**First Meeting of the APIRG Performance Based Navigation/Global
Navigation Satellite System Task Force (PBN/GNSS TF/1)
(Nairobi, Kenya, 12 - 14 October 2010)**

**PROPOSALS FOR THE AMENDMENT OF ANNEX 10, VOLUME I, CONCERNING ILS
COVERAGE REQUIREMENTS, GNSS SIGNAL-IN-SPACE PERFORMANCE
REQUIREMENTS AND GLONASS SYSTEM REQUIREMENTS**

Ref.: AN 7/1.3.94-09/46

Subject: Proposals for the amendment of Annex 10, Volume I, concerning instrument landing system (ILS) coverage requirements, global navigation satellite system (GNSS) signal-in-space performance requirements and GLObal NAVigation Satellite System (GLONASS) system requirements

Figure C-7. Localizer coverage with respect to azimuth

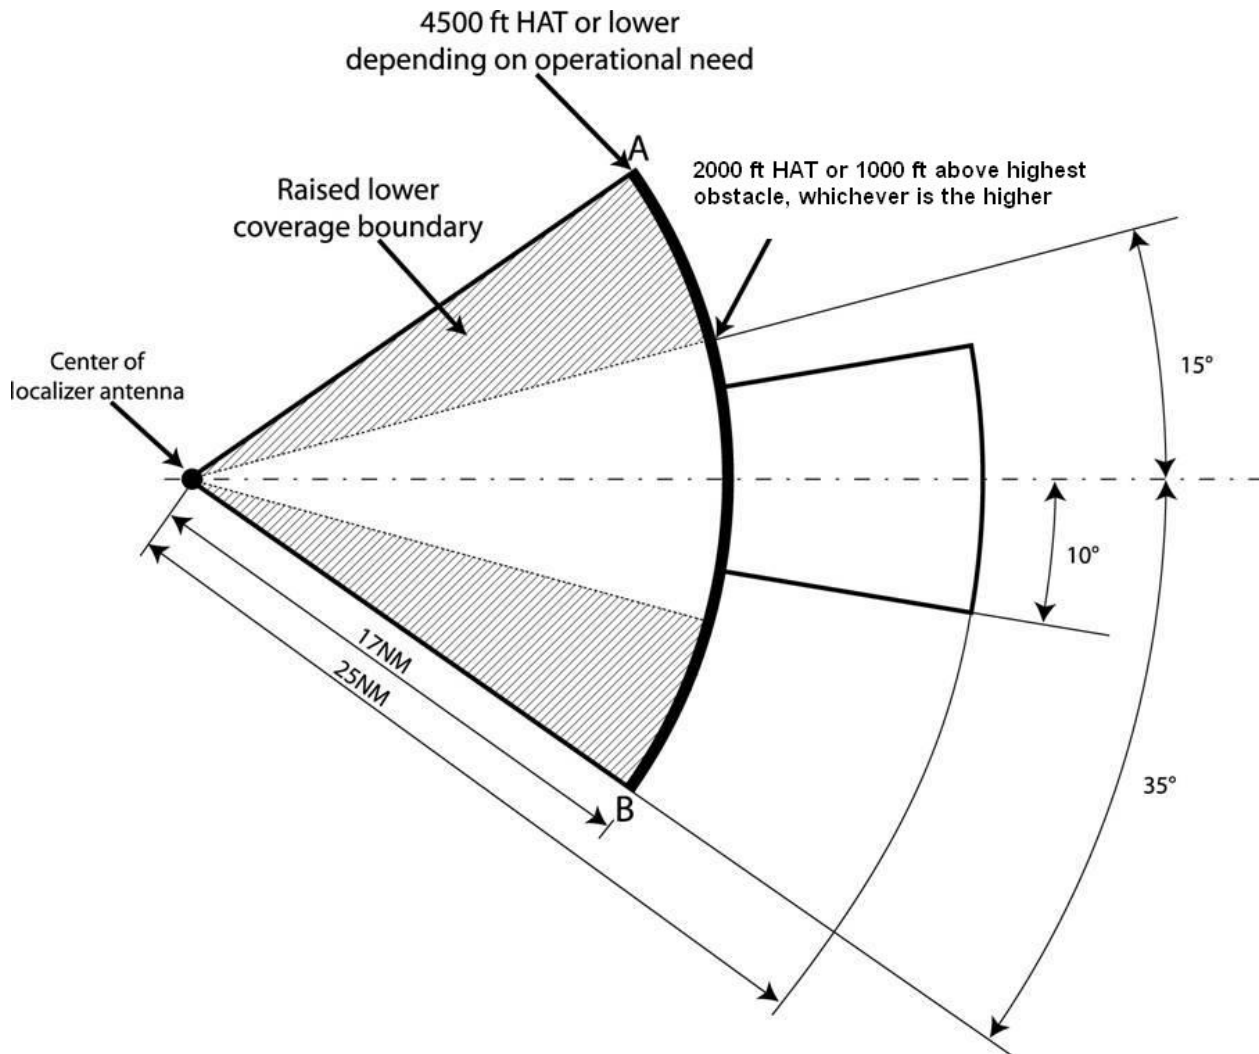
Editorial Note.— Replace Figures C-7 and C-8 with the following figures.
